**Ladder Diagrams for Error
Recovery For FCP -2 Rev 04
Out-Of-Order Delivery- Annex D**

T10/00-137r1

Reference: T11/00-133r0

D.3 Class 2 FCP_XFER_RDY Lost

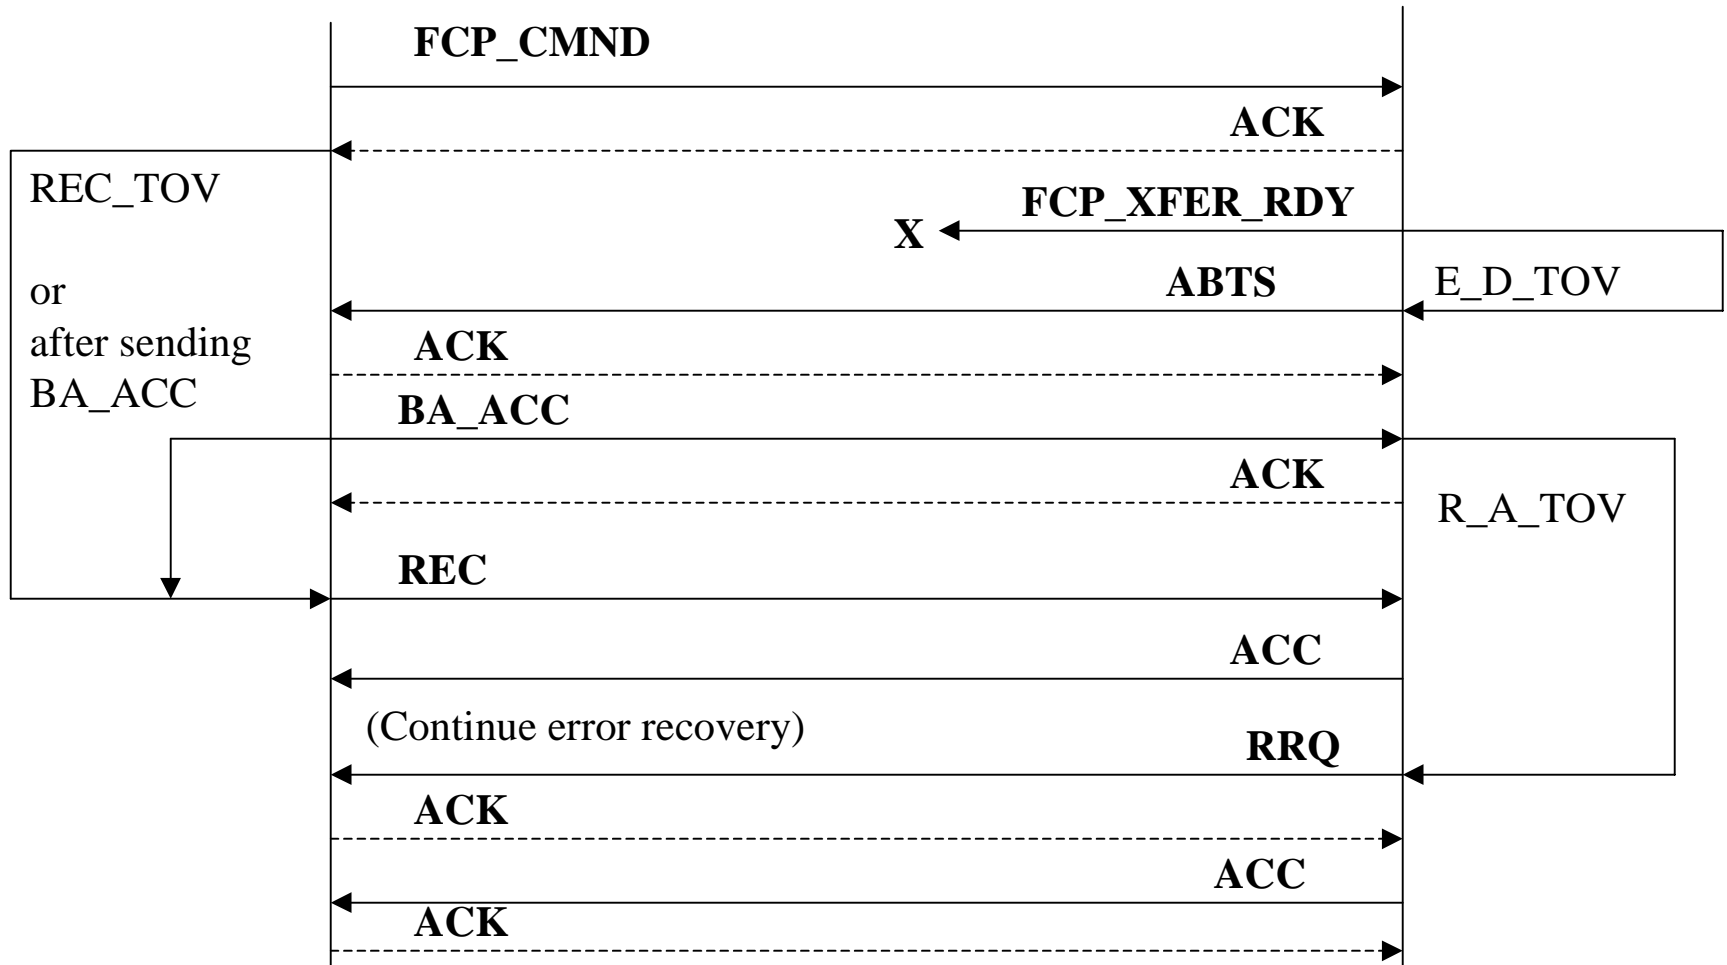
Error Recovery Addition

A new **SEQ_ID** must be used in the retransmission of **FCP_XFER_RDY**. For Class 2, the **SEQ_CNT** value used must be one greater than the value used in the **ABTS** frame. The **ACKs** for **REC/ ACC** are not shown.

D.5 Class 2 FCP_RESP Lost, No FCP_CONF Req.

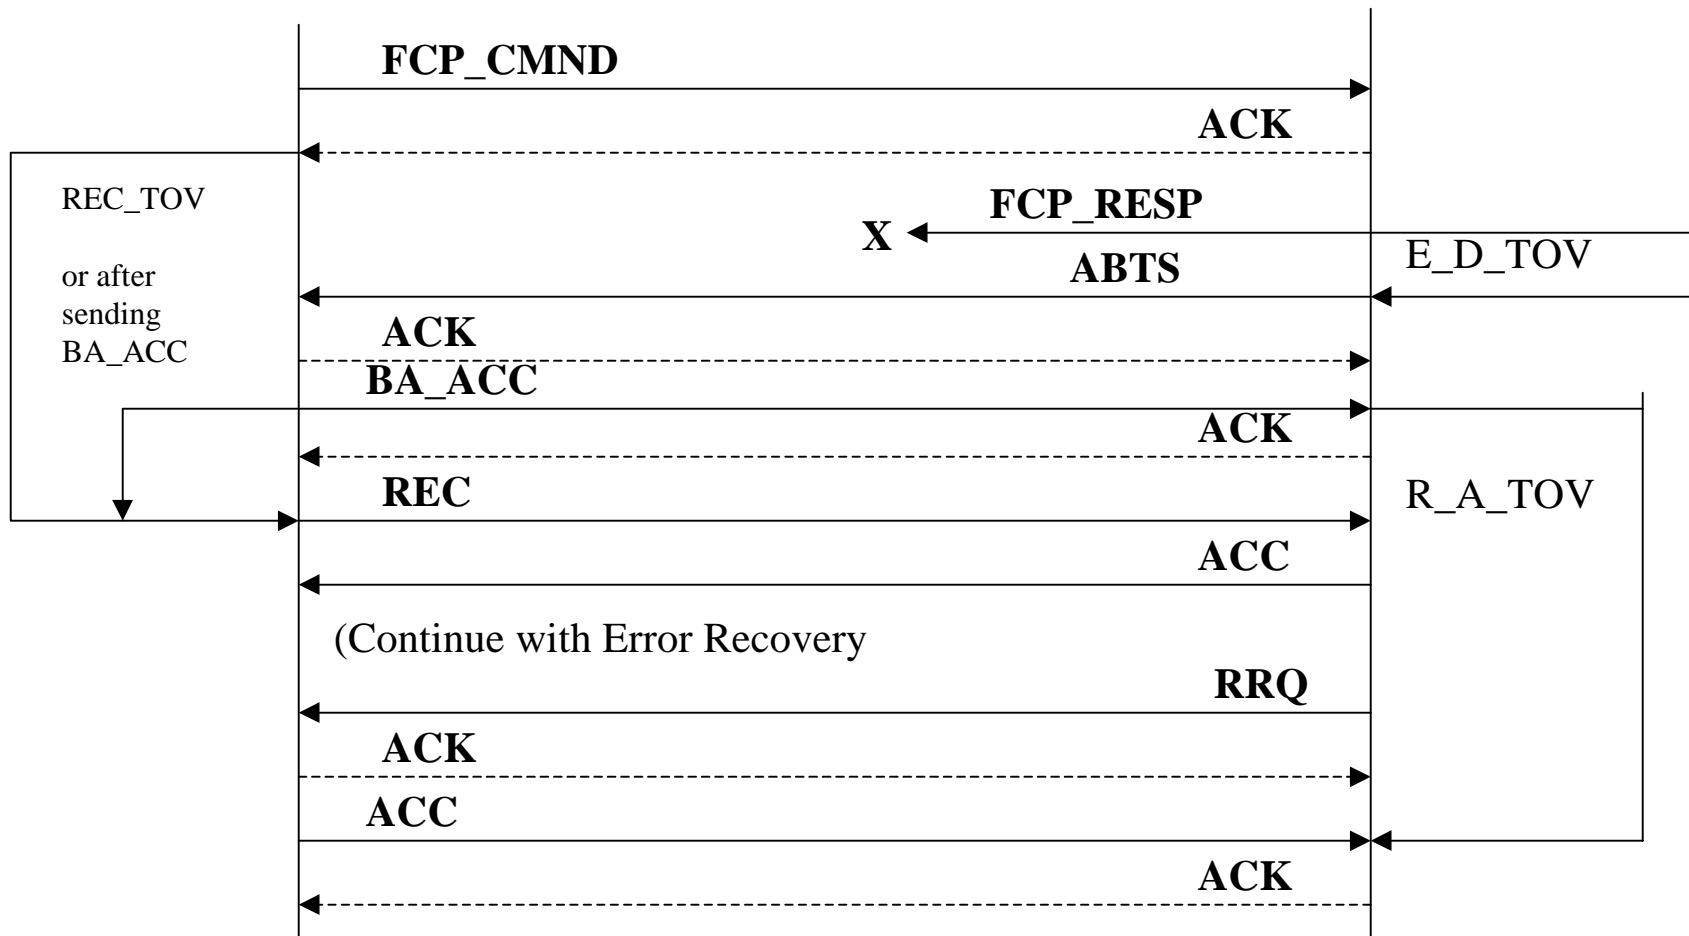
Error Recovery Addition

A new SEQ_ID must be used in the retransmission of FCP_RESP. For Class 2, the SEQ_CNT value used must be one greater than the value used in the ABTS frame. The ACKs for REC/ACC are not shown.

D.8 Class 2 Lost Write Data, Not Last Frame of Seq.

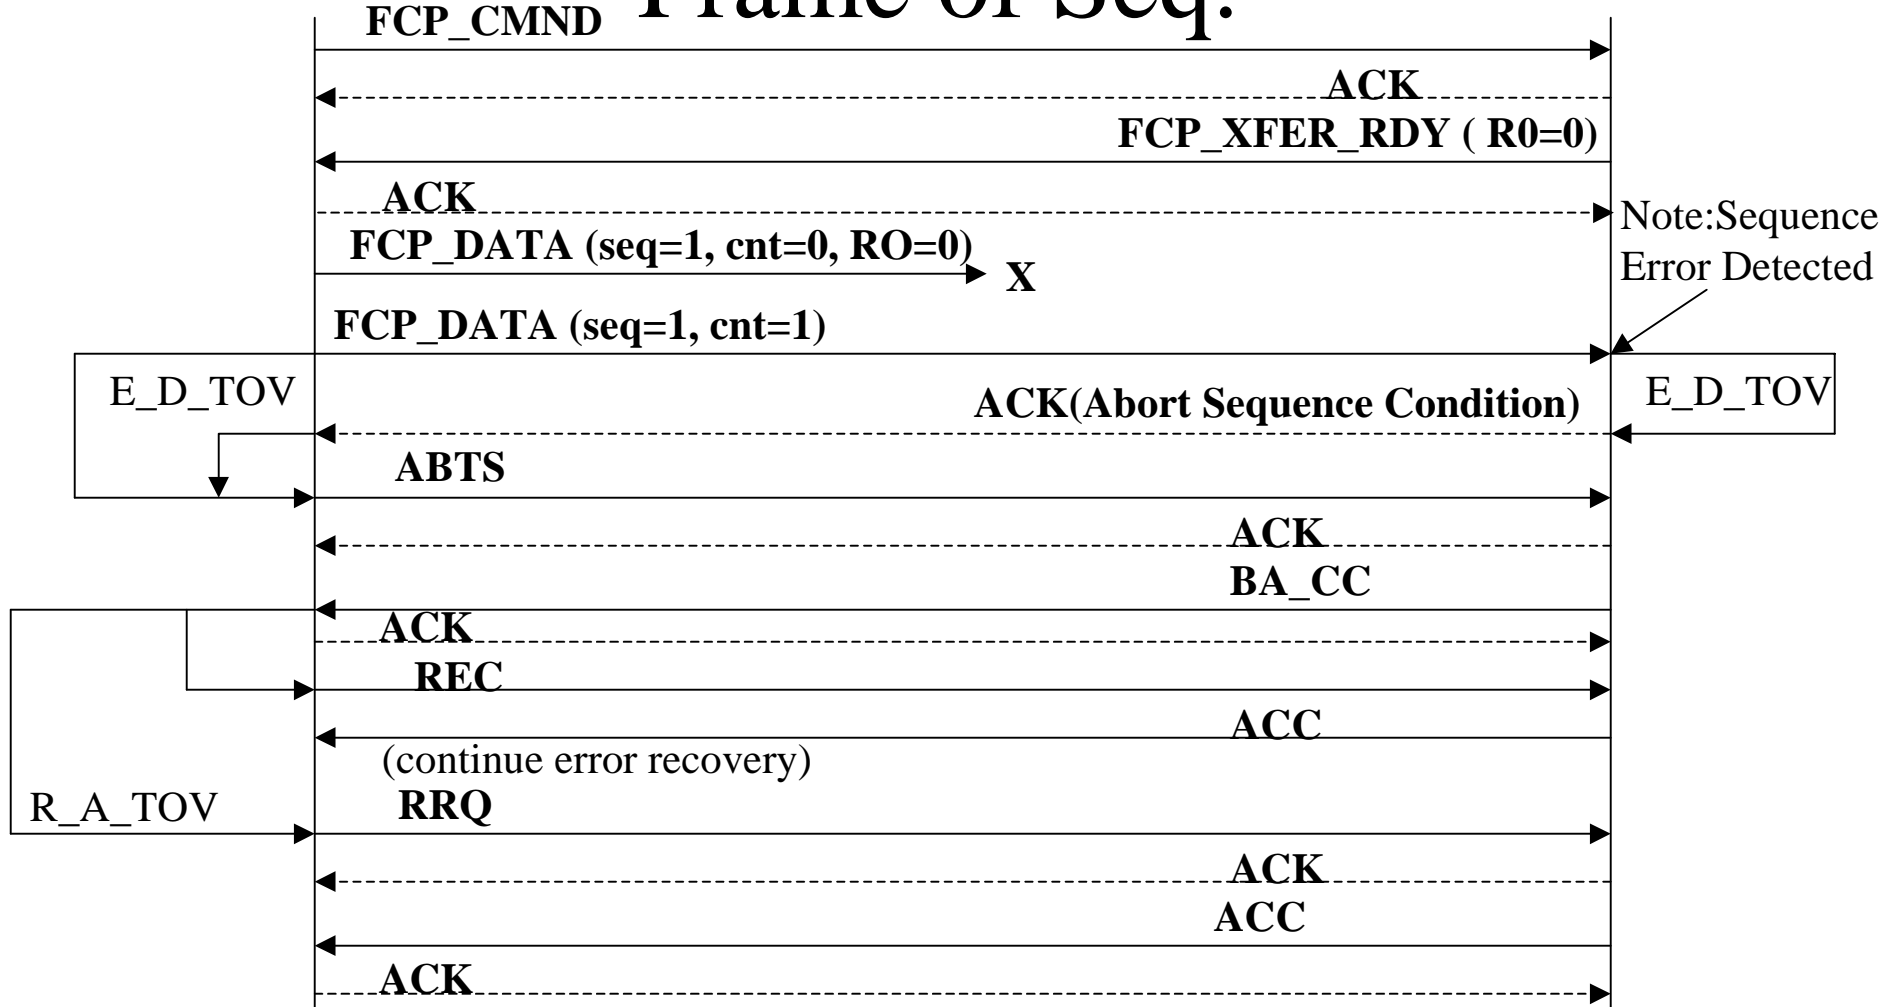
Error Recovery Addition

New Sequence IDs shall be used for retransmission of FCP_XFER_RDY and FCP_DATA. For Class 2, the Sequence count value used with the retransmission of FCP_DATA shall be one greater than the value used in ABTS. Note that if all data frames arrive at the Target prior to the expiration of E_D_TOV, (out-of-order) then there is no error and no recovery is necessary. ACKs for REC/ACC are not shown.

D.9 Class 2 Lost Read Data, Last Frame of Seq.

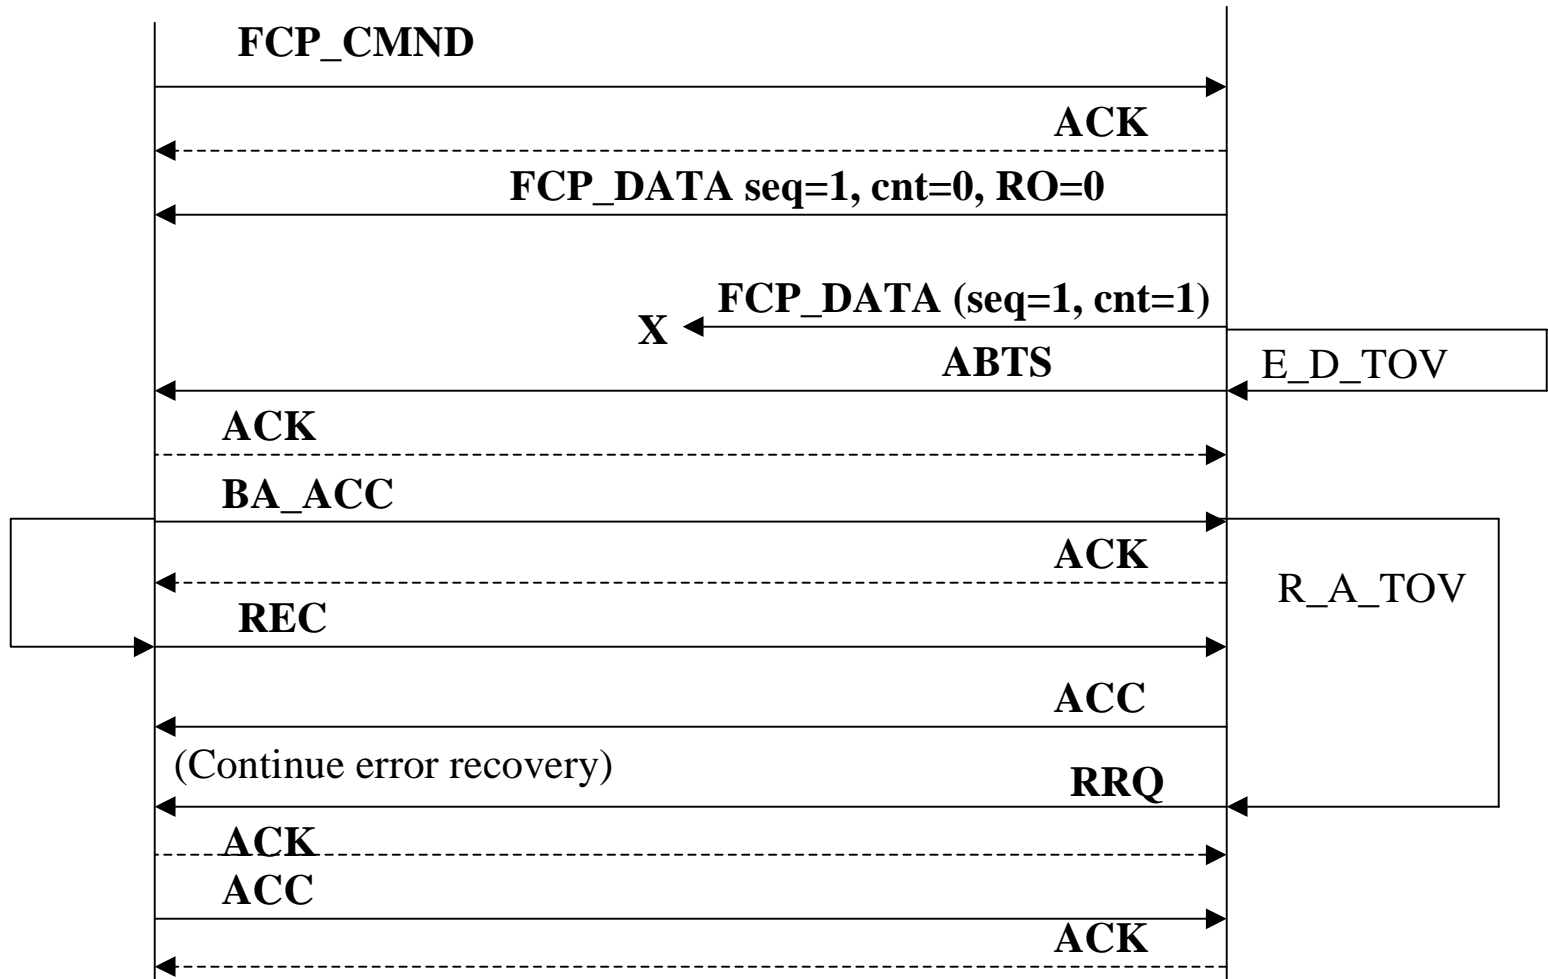
Error Recovery Addition

New Sequence IDs shall be used for retransmission of FCP_XFER_RDY and FCP_DATA.

For Class 2, the Sequence count value used with the retransmission of FCP_DATA shall be one greater than the value used in ABTS. The ACKs for REC/ACC are not shown.

D.13 C1 3,REC or REC Response Lost

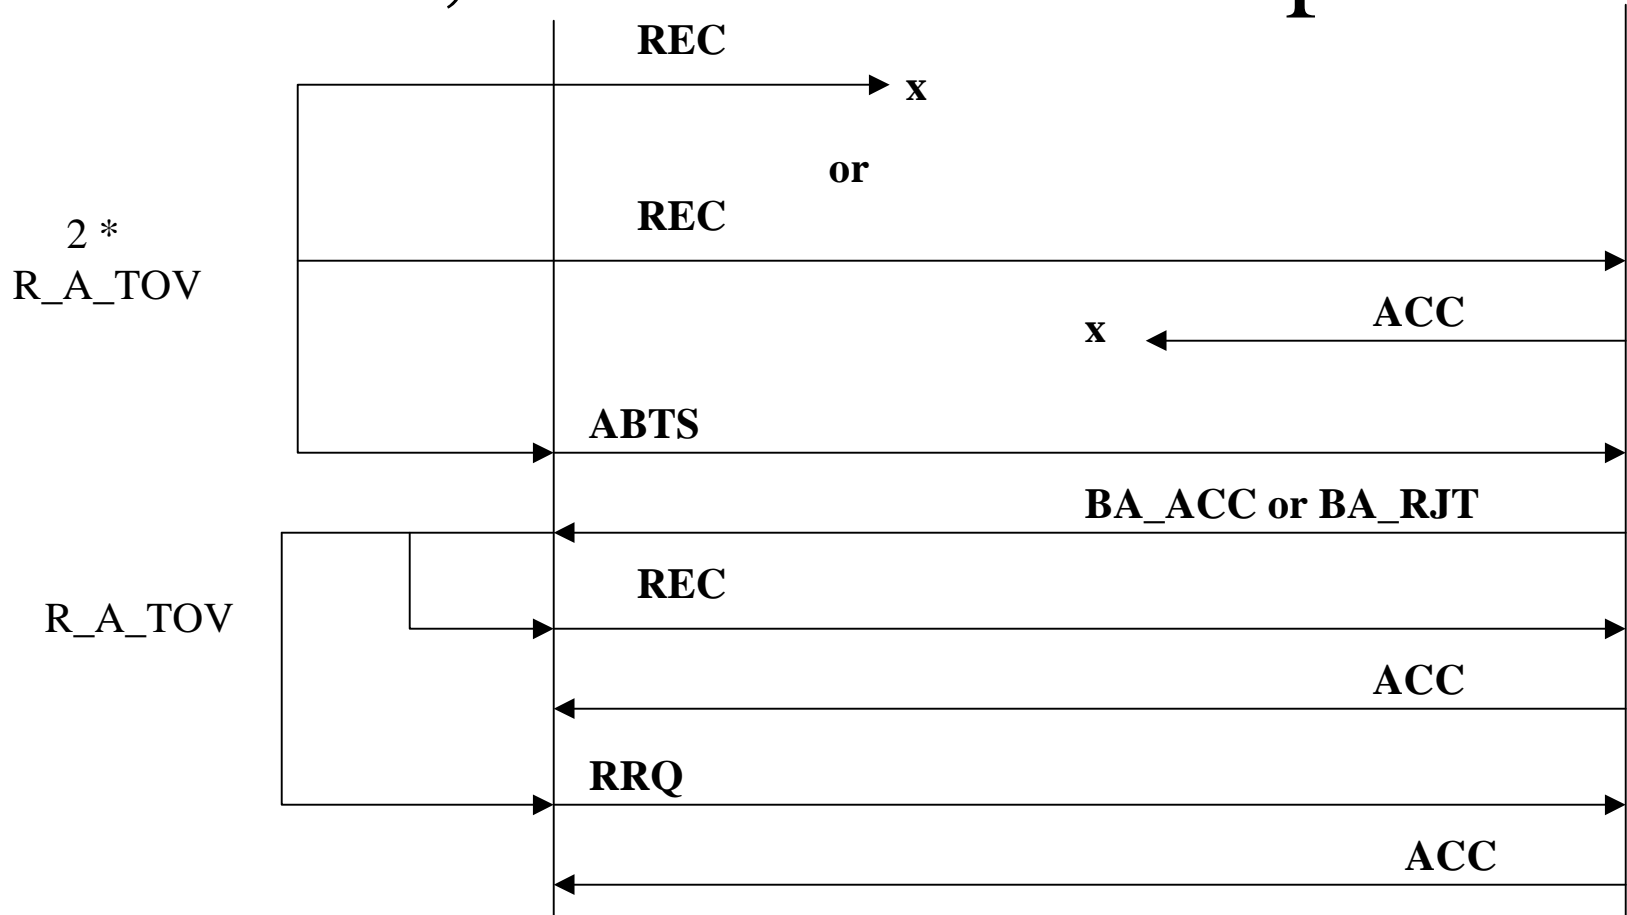
Change E_D_TOV in the text to $2 * R_A_TOV$ to agree with the text in 12.6.2

D.14a Class 3, SRR Lost

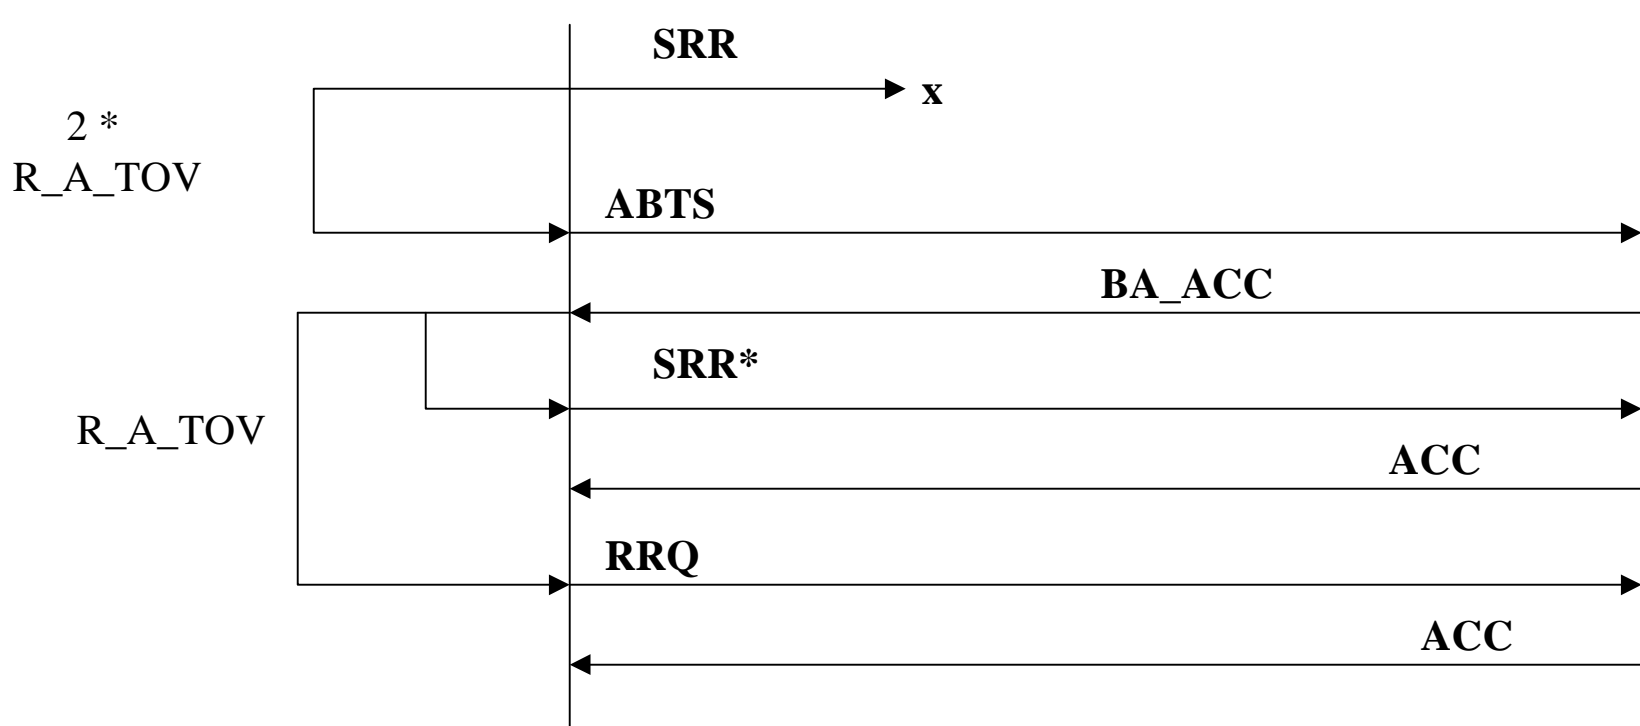
Change E_D_TOV in the text to 2 * R_A_Tov to agree with the text in 12.6.3

D.14b Class 3, SRR Response Lost

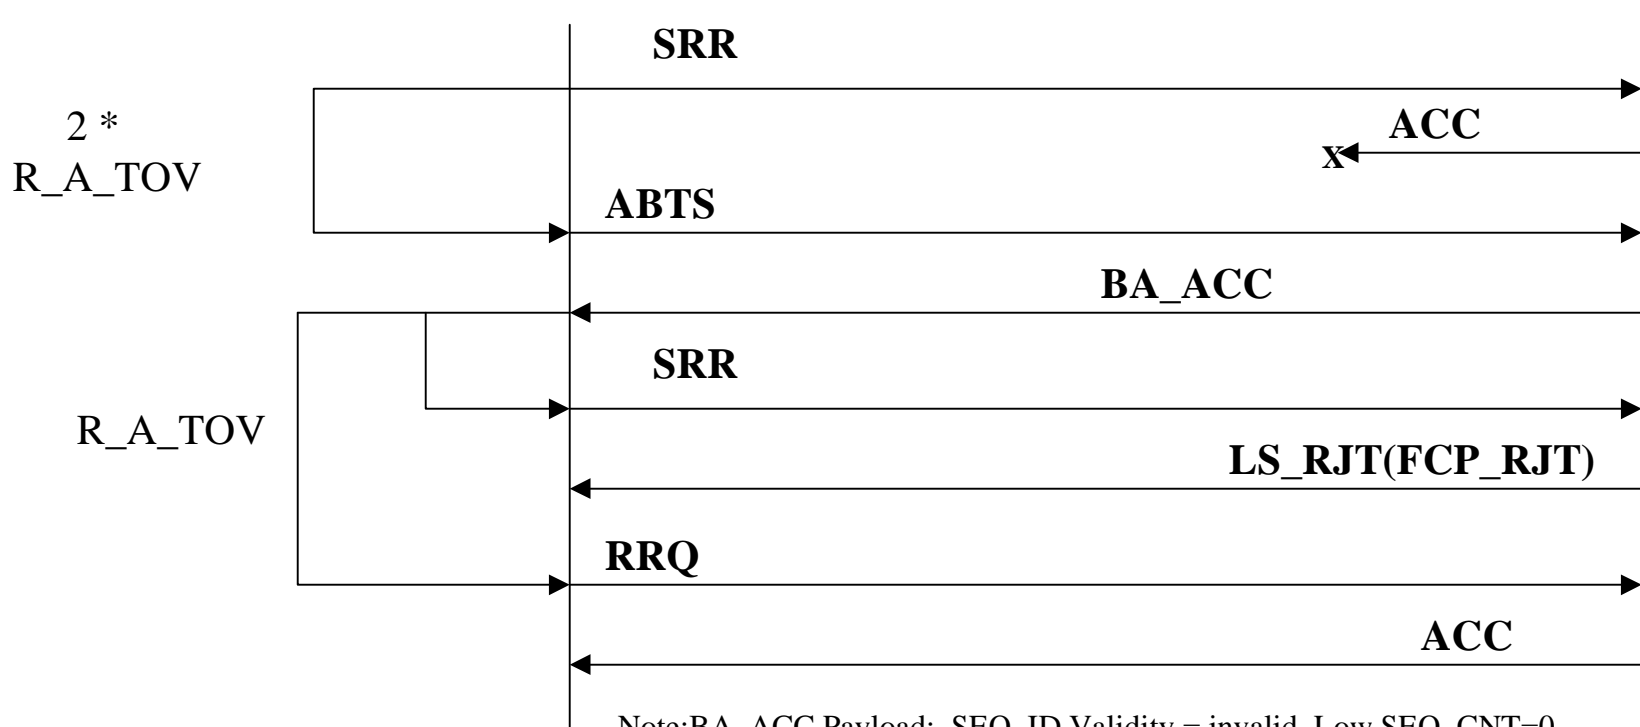
Change E_D_TOV in the text to 2 * R_A_TOV to agree with the text in 12.6.3
